**Application for Observations to a Neighbouring Planning Authority**

<b>Reference</b>	PA/24/00657 (GLA reference 2023/0836)
<b>Site</b>	Plot 1 at the former Bishopsgate Goods Yard site, Braithwaite Street, London, E1
<b>Ward</b>	Weavers (LB Tower Hamlets), Hoxton East and Shoreditch (LB Hackney)
<b>Proposal</b>	Observations requested by the Greater London Authority (GLA) in relation to 'Application for all Reserved Matters Approval (Access, Appearance, Landscaping, Layout and Scale) in respect of Plot 1 (GLA reference 2023/0836), pursuant to LB Tower Hamlets outline planning permission reference PA/14/02011 (GLA reference GLA/1200cd/12); LB Hackney planning permission reference 2014/2427 (GLA reference GLA/1200cd/13) dated 25/03/2022, for the erection of a building comprising 51,309 sq m of office floorspace (Class B1), 831 sq m retail uses (Use Class A1-A5), 6,392 sq m plant and ancillary space, landscaping, public realm, and all associated works.'
<b>Summary Recommendation</b>	Raise objections and detailed comments in response to a request for observations from the Greater London Authority

**EXECUTIVE SUMMARY**Plot 1 (RMA Site)

Appendix 1.8: Proposed ground floor plan with minimum parameter building footprint in blue outline and maximum parameter building footprint in green outline. LB Tower Hamlets is to the right/ east of yellow line

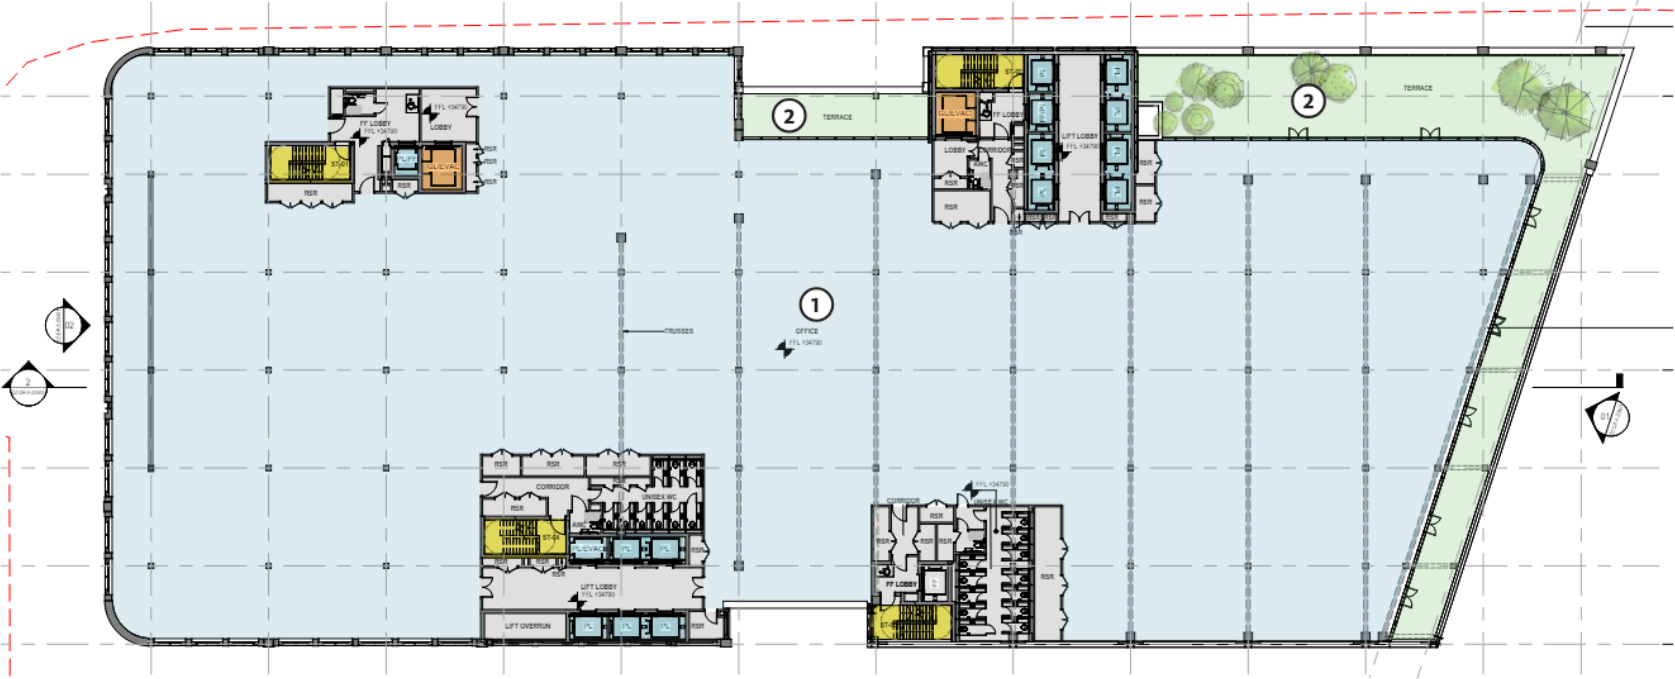
- 7.67 It is proposed to lower the headroom on vehicles using the Bethnal Green Road service yard within Plot 1 (see appendix 1.8) from 4.5m to 4.2m – the GLA should ensure that this is reflected in the service management plan (secured by s106 legal agreement) or otherwise by condition, with restrictions put on the type of service vehicles to ensure no over-height vehicles attend the site and then need to either reverse out to the public highway.
